SUNDRY NOTICES AND REPORTS ON WELLS
Do not use this form for proposals to drill or to re-enter an abandoned well. Use Form 3160-3 (APD) for such proposals.

| 3a. Address 370 17th Street, Suite 1700 Denver, CO 80202 | 3b. Phone No. (include area code) 720-876-3989 | 10. Field and Pool or Exploratory Area Wildcat (Gallup) |

Encana Oil & Gas (USA) Inc. (Encana) would like to amend the spacing unit dedicated to the Meadows I08-3014 01H oil well from 320 acres to 160 acres. This change is due to revised New Mexico Oil and Gas Regulations that became effective on February 15, 2012 that limit project areas to contiguous spacing units penetrated by the well bore.

As a result of the project area dedication, Encana has revised the well bore to satisfy setback requirements. Revising the well bore results in the following changes:

Project: San Juan Co, NM
Site: S8-T30N-R14W
Well: Meadows I08-3014 01H
Wellbore: HZ
Design: Plan #6

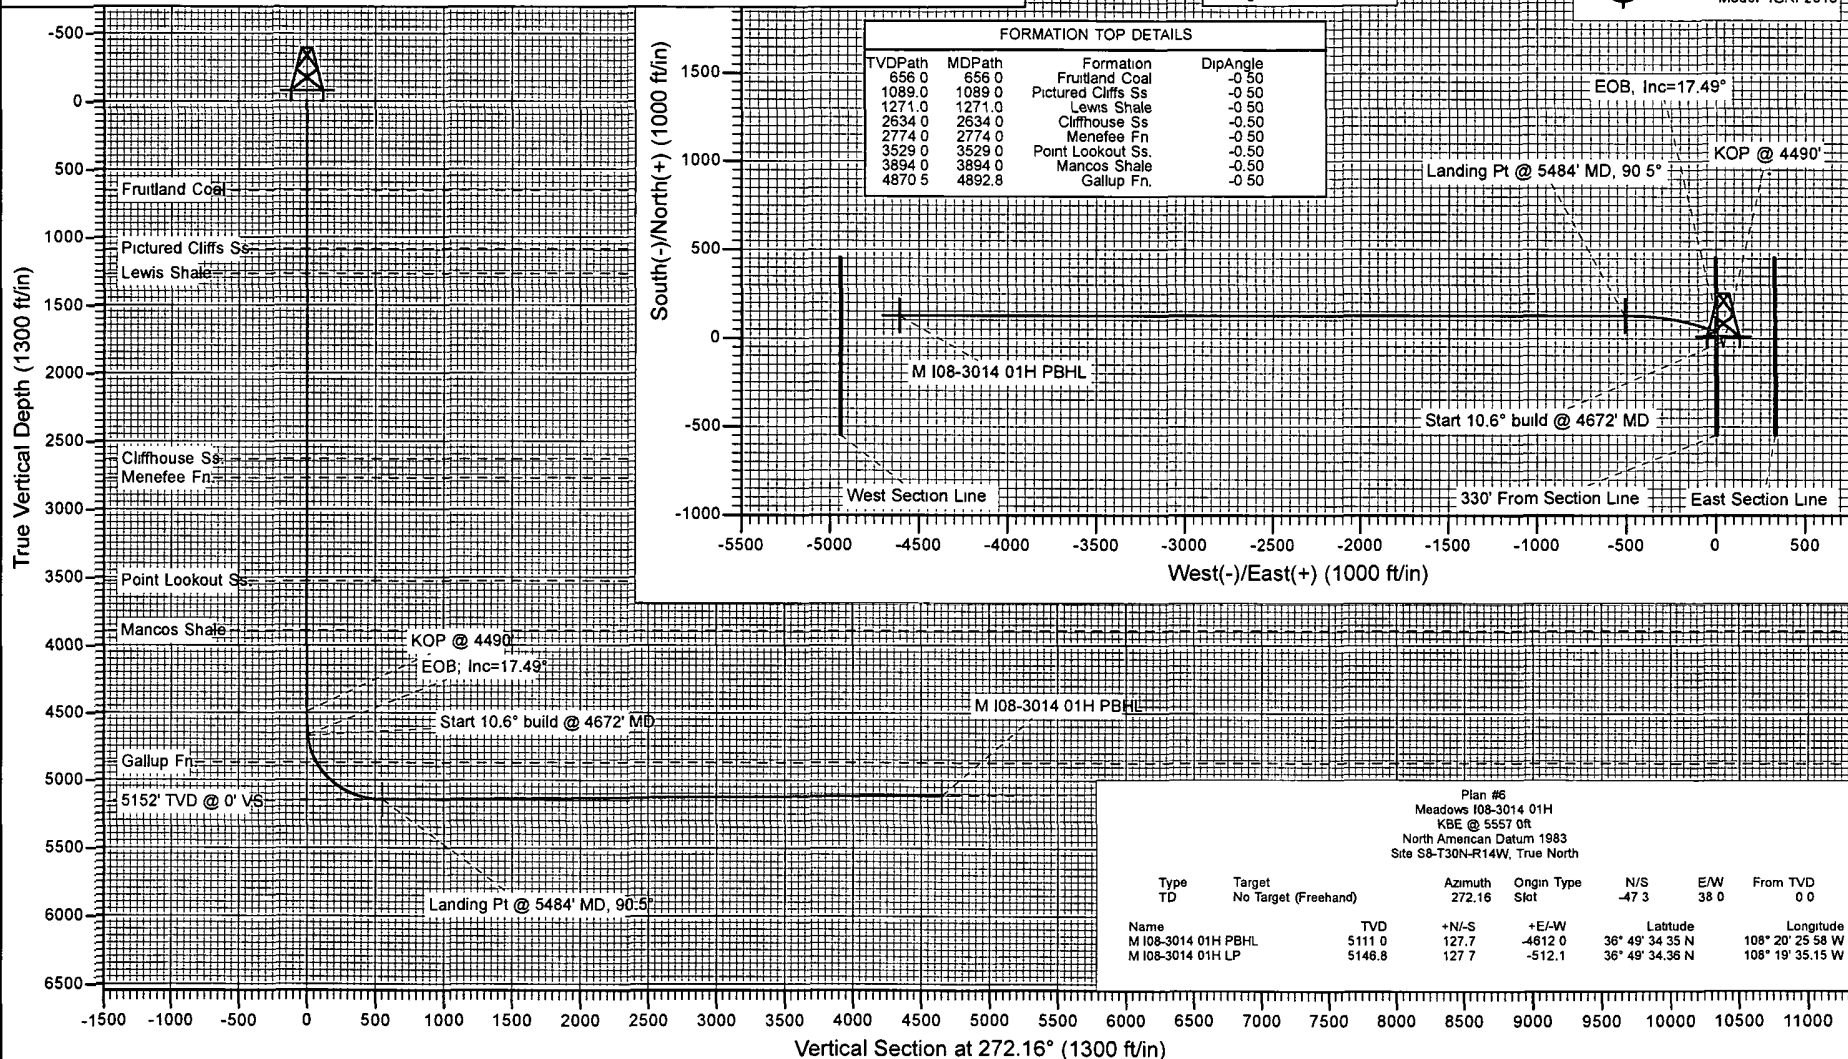
Proposed Wellbore TD is 5111' TVD/9585' MD (original approval was 5108' TVD/9519' MD)

Proposed KOP is 4490' TVD/MD (original approval was 4571' TVD/MD)

Proposed lateral is 4101' (original approval was 4043')
